Service Bulletin

Elevator Hinge Upgrade

GA8 serial numbers GA8-04-054 through GA8-07-114, and any GA8 aircraft prior to S/N GA8-04-054 retrofitted with machined hinge brackets by Engineering Release.

Figure 1

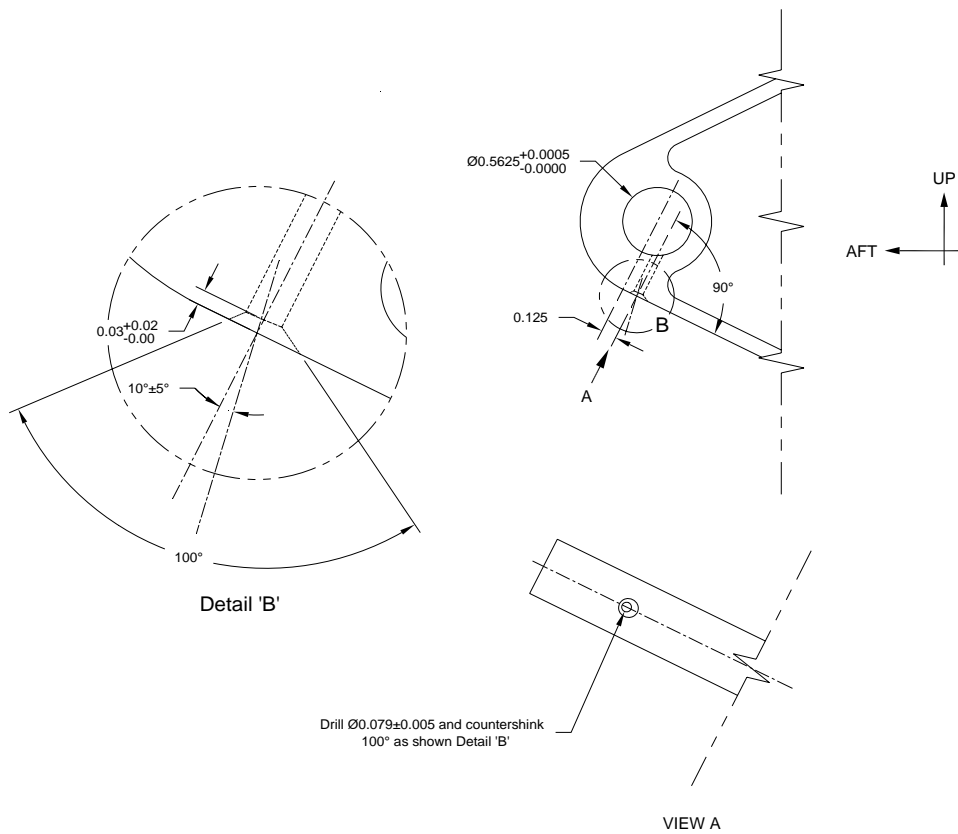
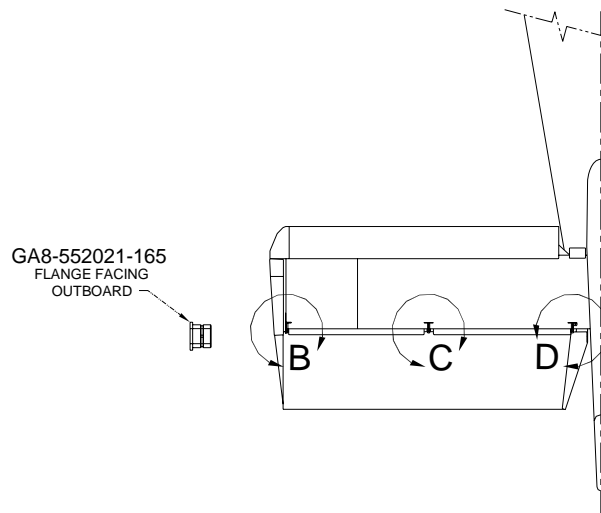
Issue 3: Lubrication hole moved 0.125". See Figure 1.

- 1.3. Drill lubrication holes of diameter 0.079" \pm 0.005" [2.00 mm \pm 0.13 mm] in the elevator hinge brackets in accordance with figure 1, and countersink at 100° as shown.

Figure 2

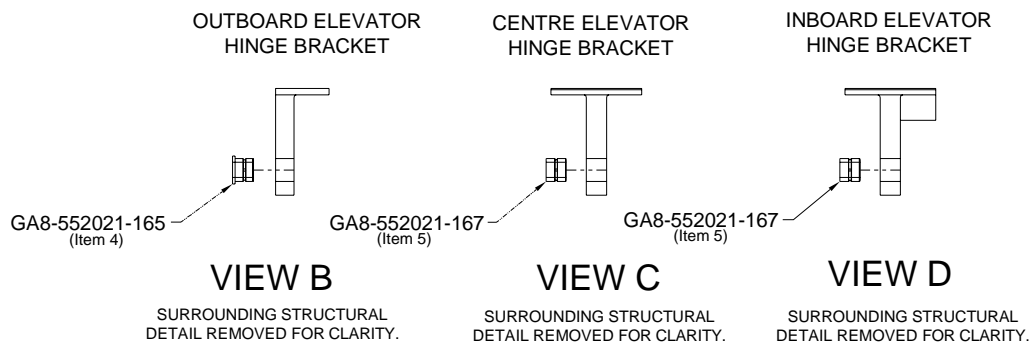
- 1.4. Install the outer bushes (items 4 and 5) with an interference fit in the respective inboard, centre and outboard hinge brackets for each elevator hinge using Loctite 603 (or equivalent), with the flange of each outboard bush located on the outboard face of the respective hinge bracket. The inboard and centre outer bushes are identical. See Figure. 2

ELEVATOR HINGE OUTER BUSH INSTALLATION
